WORKING DRAFT OF NEC CODE-MAKING
PANEL 2 MEETING OUTPUT

Document: National Electrical Code®

Revision Cycle: A2025

Panel Activity: Comment Stage

Figure 210.52(C)(1) Determination of Area Behind a Range, Counter-Mounted Cooking Unit, or Sink.

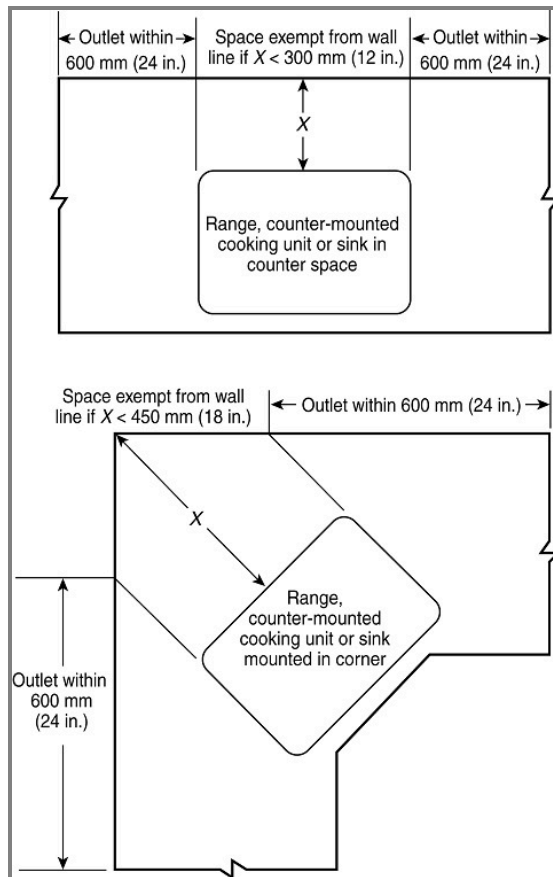
Exception No. 1: Receptacle outlets shall not be required directly behind a range, counter-mounted cooking unit, or sink in the installation described in Figure 210.52(C)(1).

Exception No. 2: Where a required receptacle outlet cannot be installed in the wall areas shown in Figure 210.52(C)(1), the receptacle outlet shall be permitted to be installed as close as practicable to the countertop area to be served. The total number of receptacle outlets serving the countertop shall not be less than the number needed to satisfy 210.52(C)(1). These outlets shall be located in accordance with 210.52(C)(3).

Exception No. 3: Receptacle outlets located in the specified location in 210.52(A)(2)(3) shall not be located within 610 mm (24 in.) of the countertop or worksurface.

Figure D.15(d) Monitoring Only Controlled Loads, All Loads Controlled.

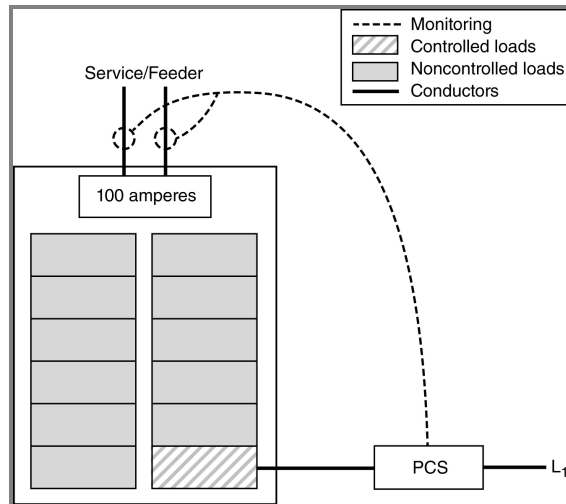
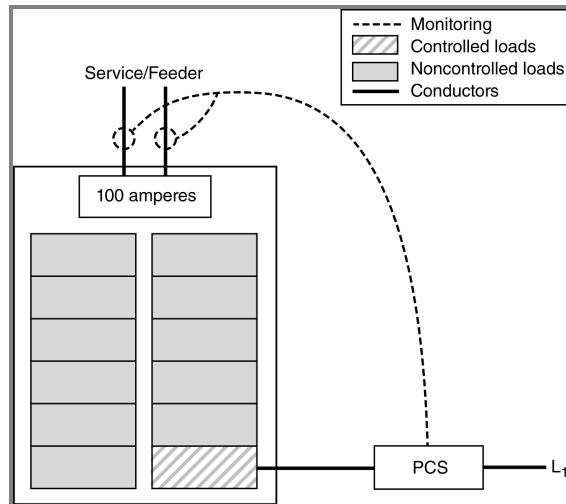
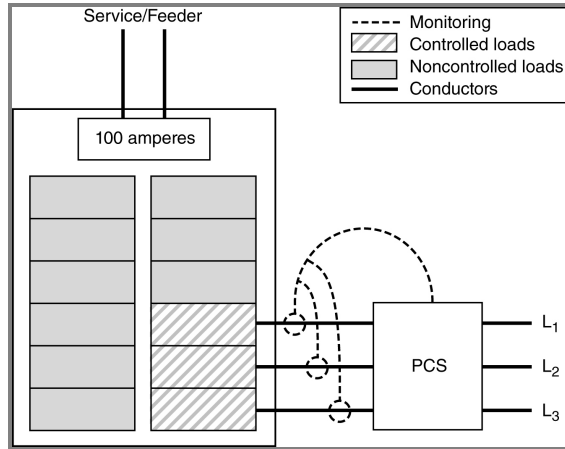
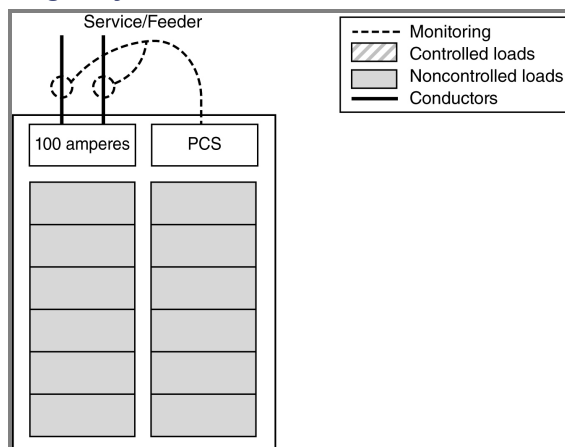
Committee Statement: The language in Example D.15 was modified to align with the changes that were made in Section 120.7. For PC 1942, refer to actions taken on PC 1939, as not all suggested revisions were included in the Second Revision to 120.7.

Figure D.15(d) Monitoring Only Controlled Loads, All Loads Controlled.

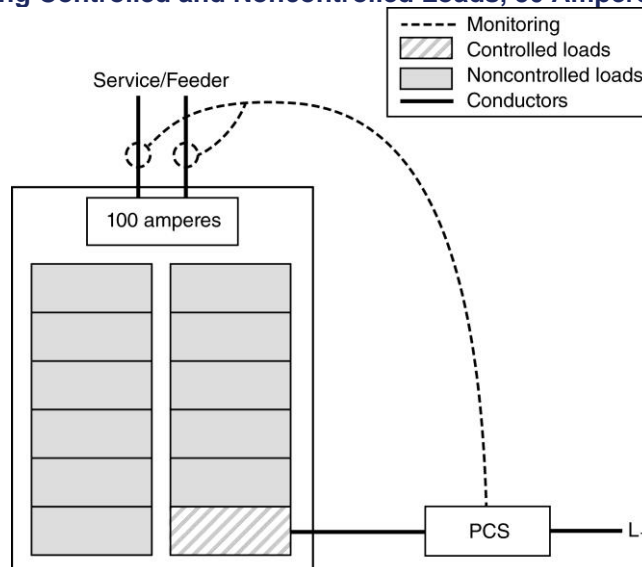
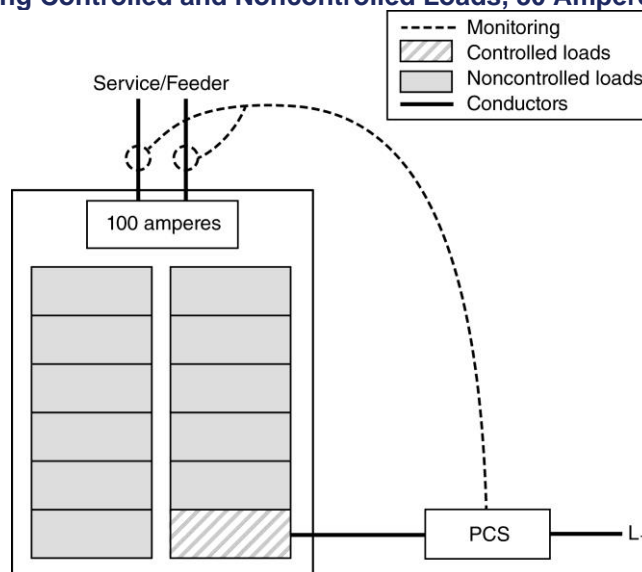
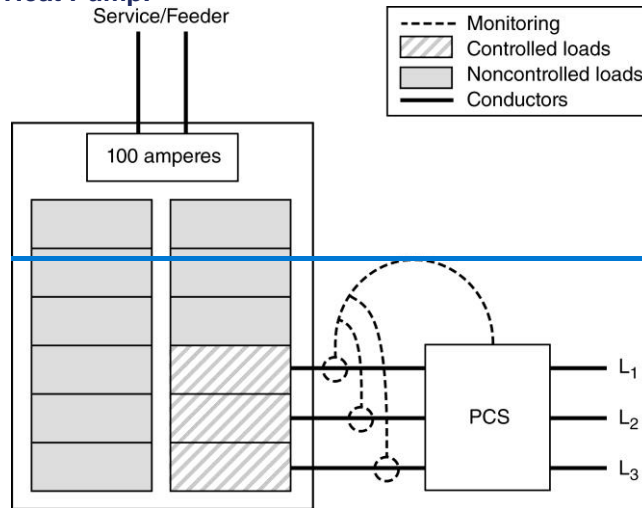
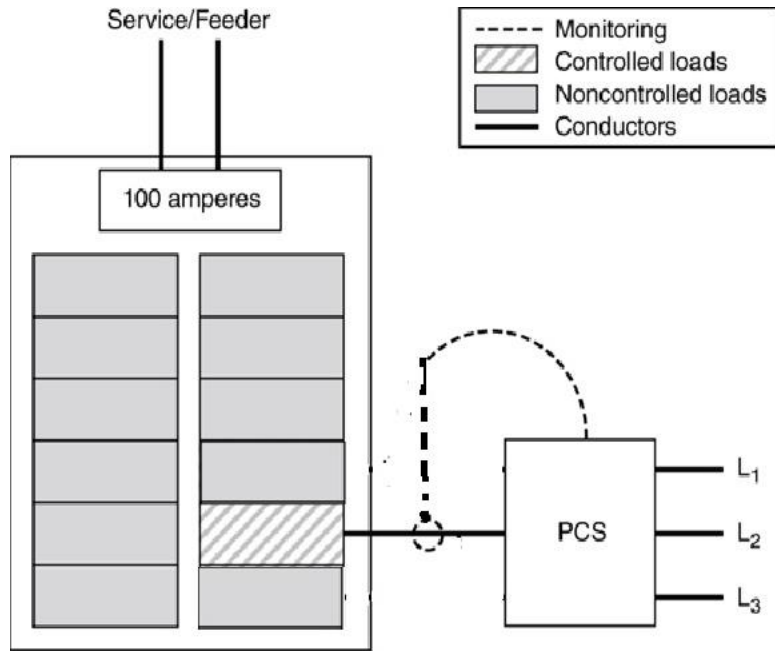
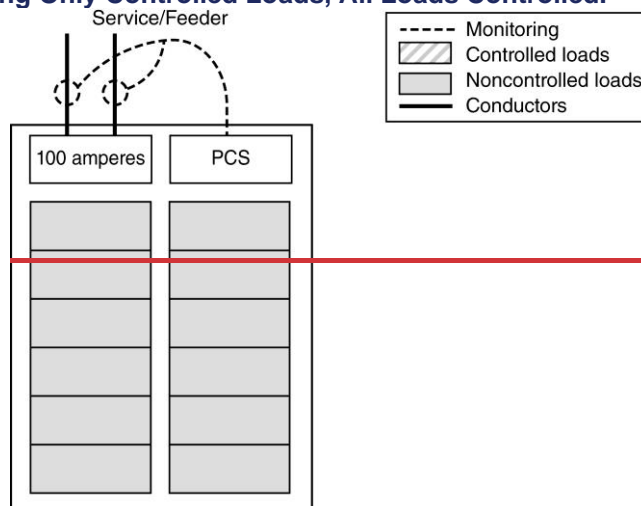
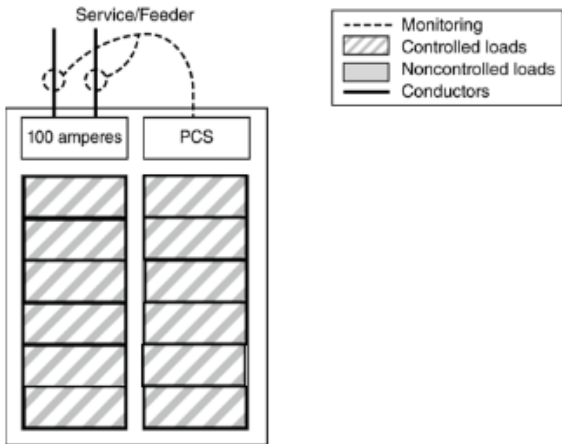
Figure D.15(D) was corrected to show that the PCS is monitoring only controlled loads.

Example D15(c) was incorrect, as it mentioned monitoring all loads, which was not consistent with the drawing. The example was modified to address recommendations in PC 1850 and ensure the drawing and the calculations in the example accurately reflect application of the requirements in 120.7.

[\[Replace Figure D.15\(C\) as shown below\]](#)
